Re: ACTION RE: PETITION FROM FOX TRAIL DEVELOPMENT, LLC. REQUESTING SITE PLAN AND DESIGN REVIEW FOR THE CONSTRUCTION OF A SINGLE-TENANT OFFICE BUILDING LOCATED AT 2110 & 2120 RIVERSIDE DRIVE, PARCELS AL-63 & AL-64 (current vacant lot)

Site Plan & Design Review – Staff Comments (reviewed 12-16-2023)

G SOUTH ELEVATION
SCALE: 1/8" = 1'-0"

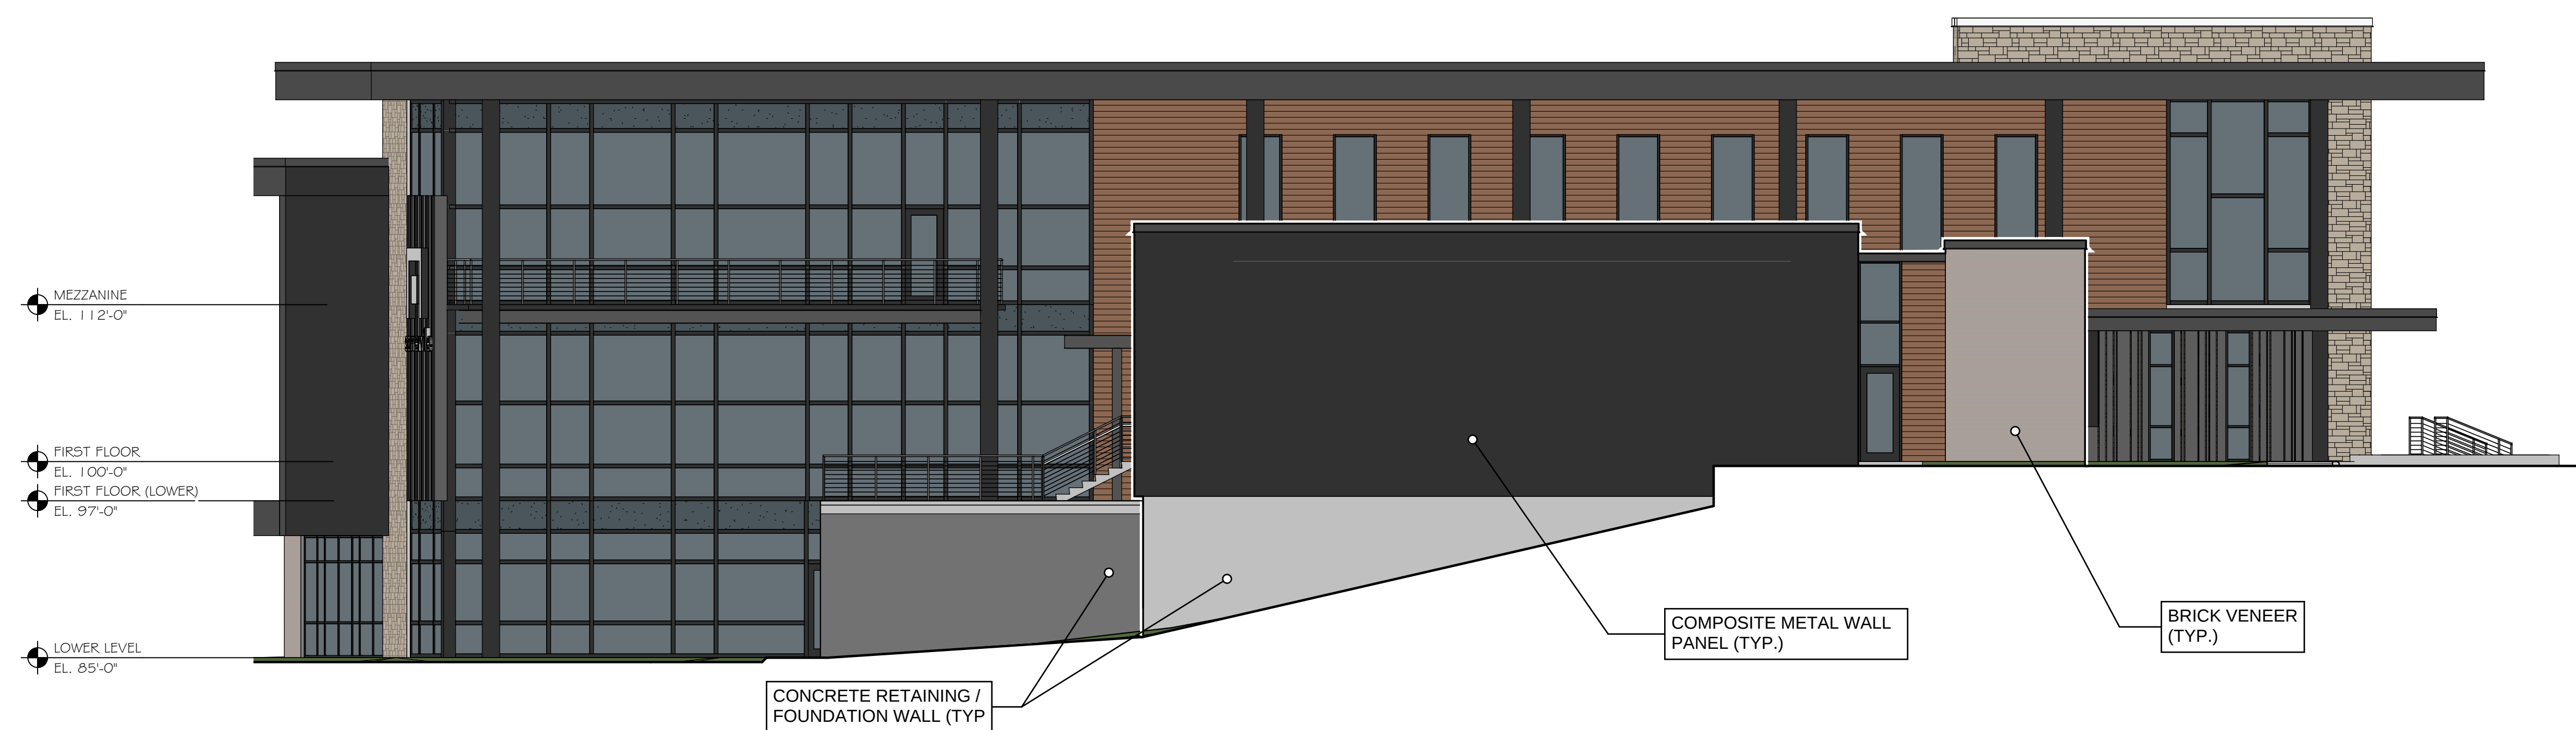
- Zoning Section 475-901C & 475-901 D:
 - Standards appear met for major and minor façade material. Staff will work with project architect to verify final material make-up.

- Zoning Section 475-901Q:
 - Standards appear met for screening of mechanical equipment. Staff will work with project architect to verify final screening.
